Technical Service Bulletin

93 Q8 e-tron - electric drive: fault. Cooling system - B16A284 B16A285 B16A384 B16A385 P053400 P0CE900 P139B00 P2B2A00

98 24 00 2072715/1 January 23, 2024.

Figure 3: Coolant hose (10).

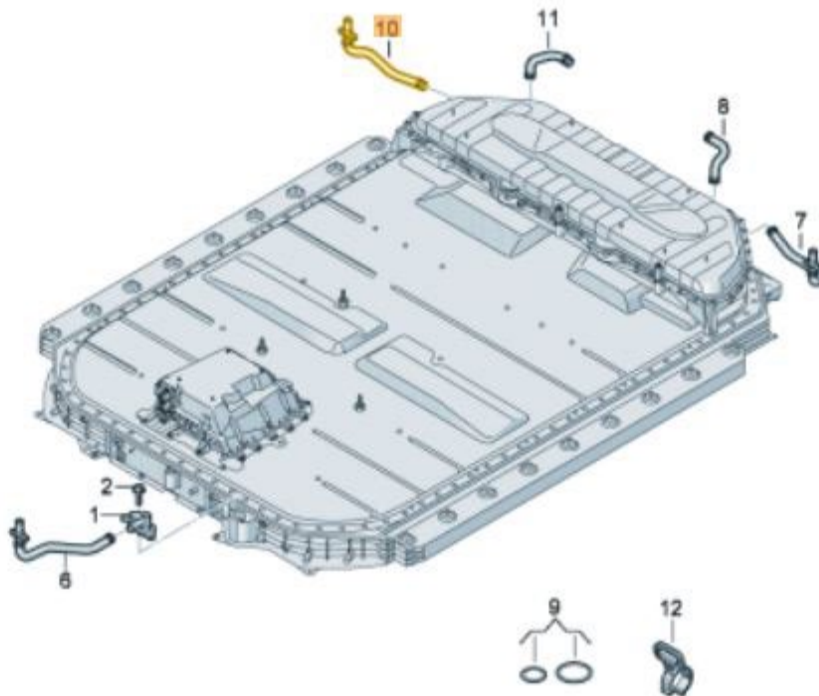
Potential damage to the cooling system hose.

Before starting repair work, order the coolant hose with part number 4KE 998 465 D in ETKA.

Perform the repair according to the Audi Workshop Manual and the attached further instructions.
